AL HILLAH POLICE FIRING RANGE
AL HILLAH, IRAQ

SIGIR PA-06-076
JANUARY 08, 2007

SUBJECT: Report on Project Assessment of the Al Hillah Police Firing Range,
Al Hillah, Iraq (Report Number SIGIR-PA-06-076)

Site Photo 8. Shooter's pit at rifle firing tubes

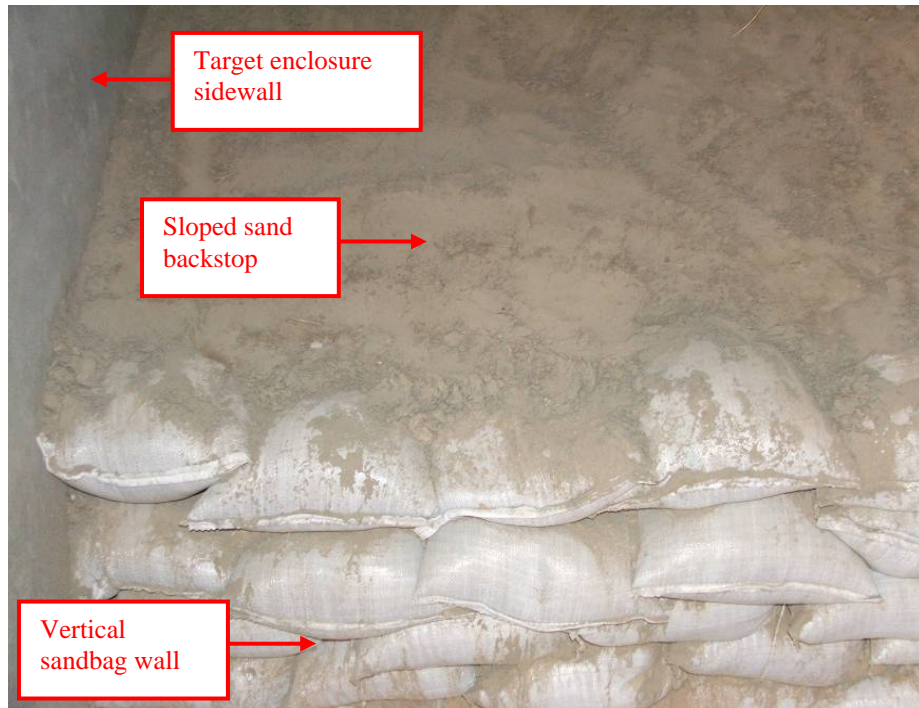
The reinforced concrete shooter's pit at the end of the firing tube was below grade so that the pit floor was 0.75 m below the floor of the firing tube. The outside dimensions of the pit were 2 m wide by 3 m long, and the pit was covered with a metal cover supported by truss frame and four steel posts. The shooter's pit contained an overhead fluorescent light fixture as well as an exterior light mounted to the outside of the metal cover frame.

Site Photo 12. Rear side of electrical panel

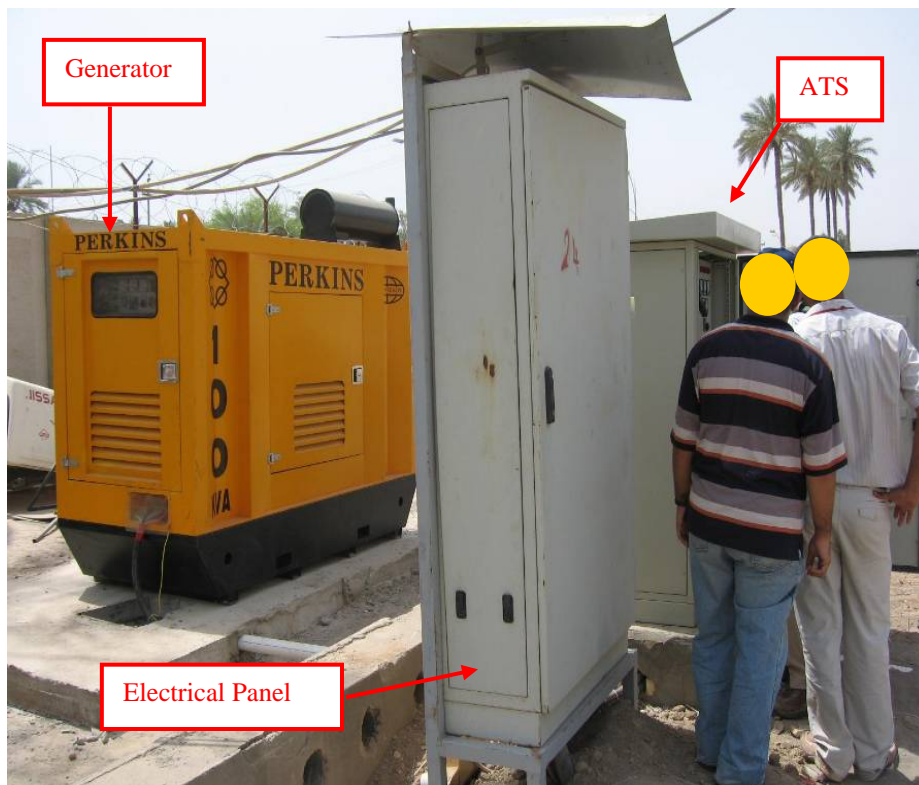
On the rear side of the electrical panel shown in Site Photo 12, we found some portions of the metal frame rusted. Additionally, the cable connecting the ATS to the panel was not enclosed in rigid conduit.
